CAMP LEJEUNE No. 5 WELL
TITLE
 VERTICAL TURBINE PUMP WITH COMBINATION RIGHT ANGLE GEAR DRIVE WITH ENGINE & MOTOR

CONTRACT NO 81-C-1644	TRANSMITTAL NO 214	DATE 5-30-86
--------------------------	-----------------------	-----------------

PROJECT TITLE AND LOCATION
Holcomb Blvd Water Treatment Plant
MCB, Cp Lejeune, North Carolina

ITEM NO	PROJ. SPEC. SECT. & PARA. and/or PROJ. DWG. NO.	ITEM IDENTIFICATION (Type, size, model no., Mfg. name, dwg. or brochure number)	NO. OF COPIES	ACTION CODES	REVIEWER'S INITIALS CODE AND DATE
	02734	ROTARY DRILLED WATER WELLS WELL # 5			
1	1.2.1	Shop Drawings	7	A	JRB

WELL #5

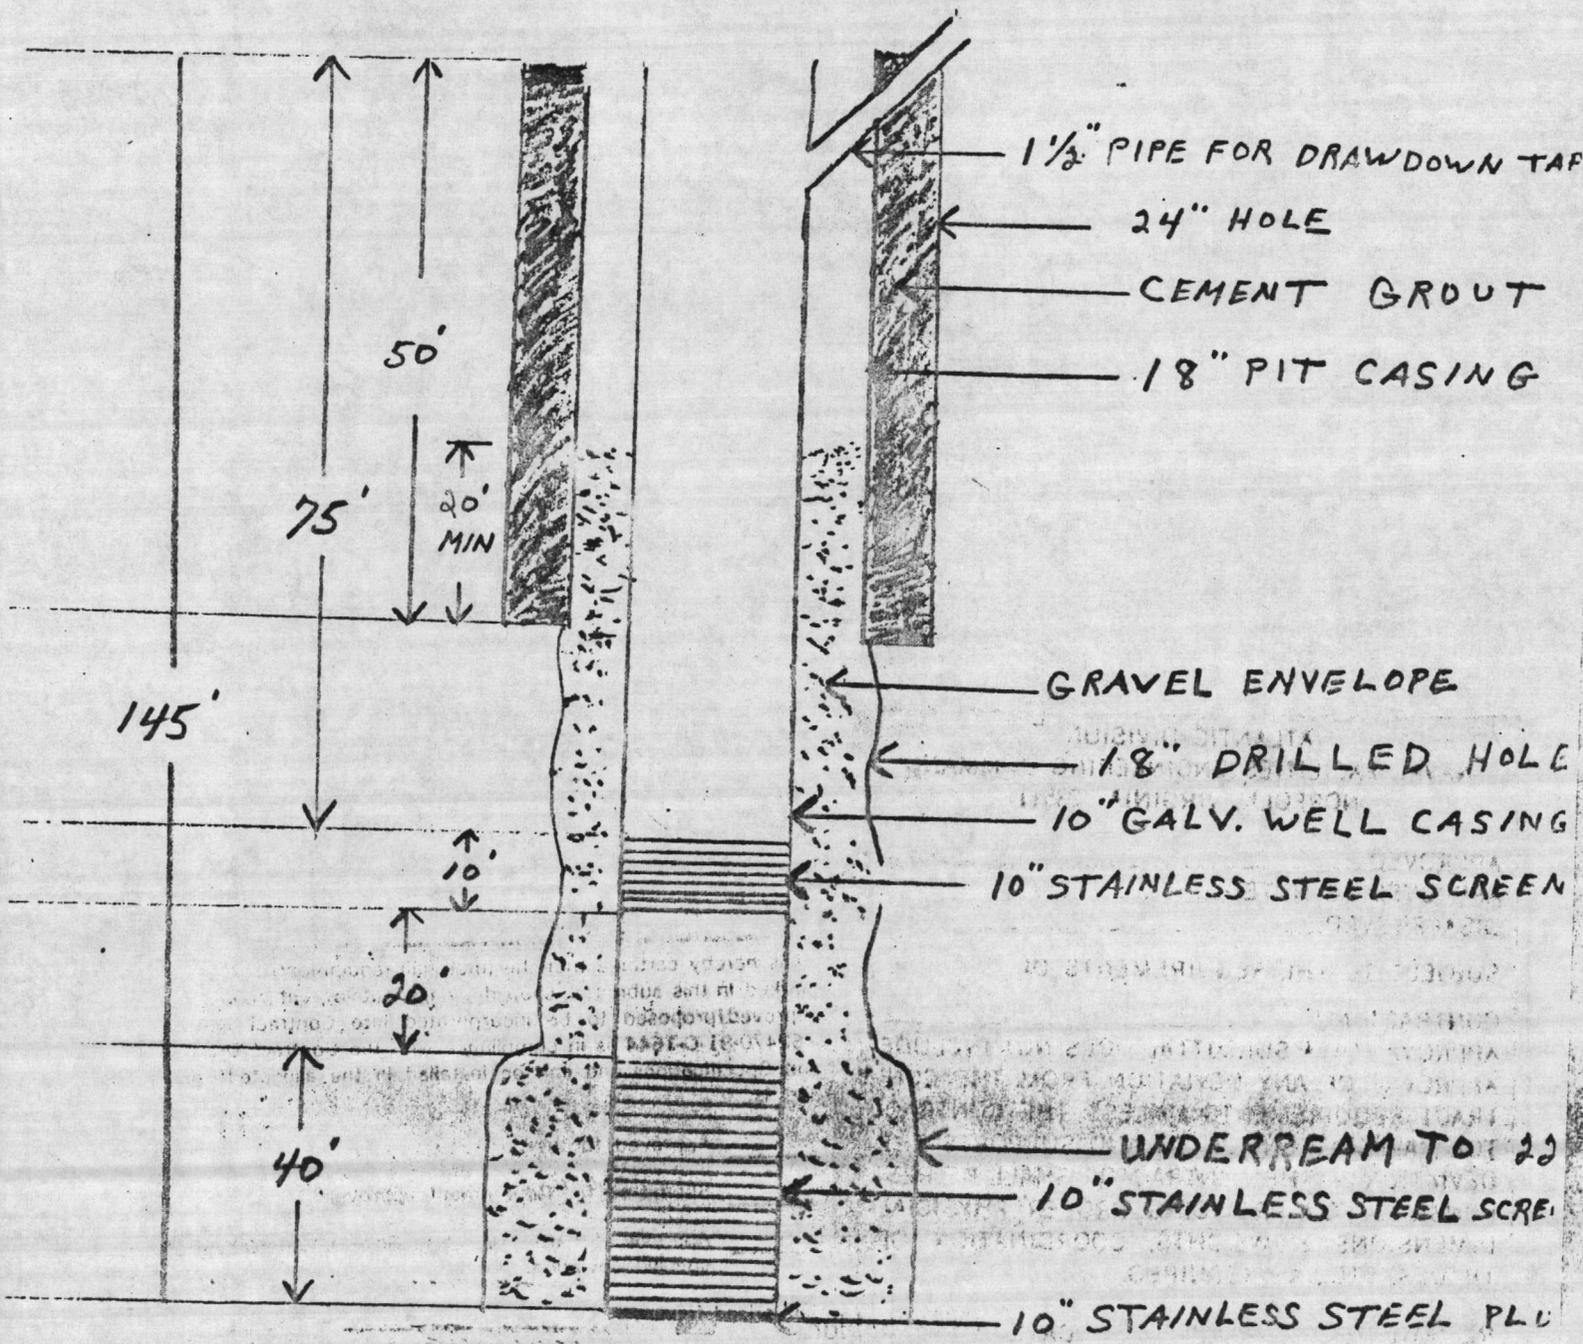
An Additional ten (10) feet of screen was added.

This Shop Drawing replaces Shop Drawing previously submitted. See Item # 6, Transmittal # 106, dated 10-16-85.
